Model: Kr-P2	Date: 10-Nov-09	No.: RM047001f
--------------	-----------------	----------------

Subject: Firmware Release Note: PS3/PDF		Prepared by: Y. Nishida	
From: MFP/Printer Tech Service Dept., 3rd Tech Service Sect..			
Classification:	<input type="checkbox"/> Troubleshooting	<input type="checkbox"/> Part information	<input type="checkbox"/> Action required
	<input type="checkbox"/> Mechanical	<input type="checkbox"/> Electrical	<input type="checkbox"/> Service manual revision
	<input type="checkbox"/> Paper path	<input type="checkbox"/> Transmit/receive	<input type="checkbox"/> Retrofit information
	<input type="checkbox"/> Product Safety	<input checked="" type="checkbox"/> Other (Firmware)	<input checked="" type="checkbox"/> Tier 2

This RTB has been issued to announce the firmware release information for the **PS3/PDF**.

Important Information About Engine PCB Replacement

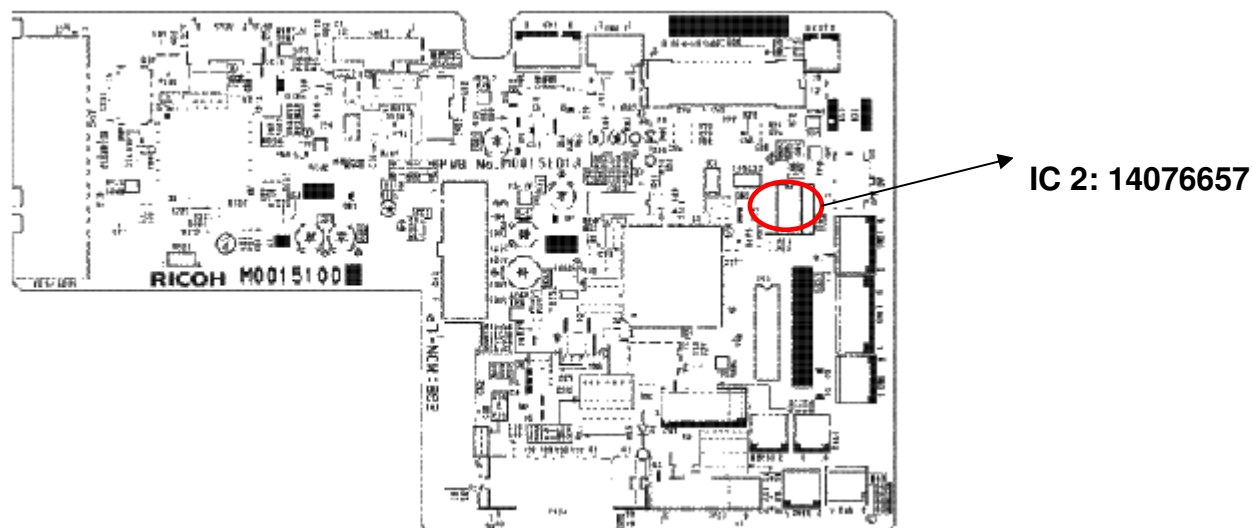
Due to the March 11 earthquake and tsunami disaster in the Tohoku region of Japan, many production facilities in the area suffered extensive damage. This has caused an interruption in the supply of electrical parts for engine PCBs used on Ricoh products. To continue machine production, a different type of CPU had to be used on engine PCBs.

- 1) As a result, a modified version of the engine firmware is preloaded on boards that use the new CPU. This change is shown in the first and second line in the table below.

- 2) The board containing the old CPU (and old firmware) is still available to order, under a new part number. This is shown in the third and forth line in the table below.

- Do not install the old firmware (v.1.05:02 or older) on the new engine board. This is because the old firmware **cannot be used** on the new board and the new firmware (v.A2.0:20 : The new version starts with "A") **cannot** be used on the old board. For this reason, **the new firmware will not be released to the field.**
- If you replace the engine board on a machine that still requires the **old** firmware version, as mentioned above, please order the board using P/N M0475016 (=M0475011) for NA, or M0475008 (=M0475005) for EU, Asia and China.

EGB

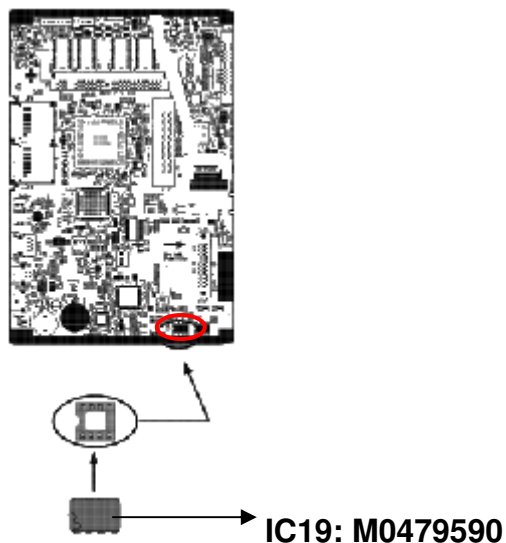
Reason/Change: The NVRAM (P/N 14076657, IC 2) on the EGB is now available as a service part. The part number for the NVRAM (P/N M0479590, IC 19) on the Controller Board was updated.

Old P/N	New P/N	Description	Q'ty	Int	Page	Index	Note
-	14076657	EEPROM: BR93L76-W	1				3D P/C
14076732	M0479590	NVRAM Counter: Zero	1-1	X/O			3D P/C
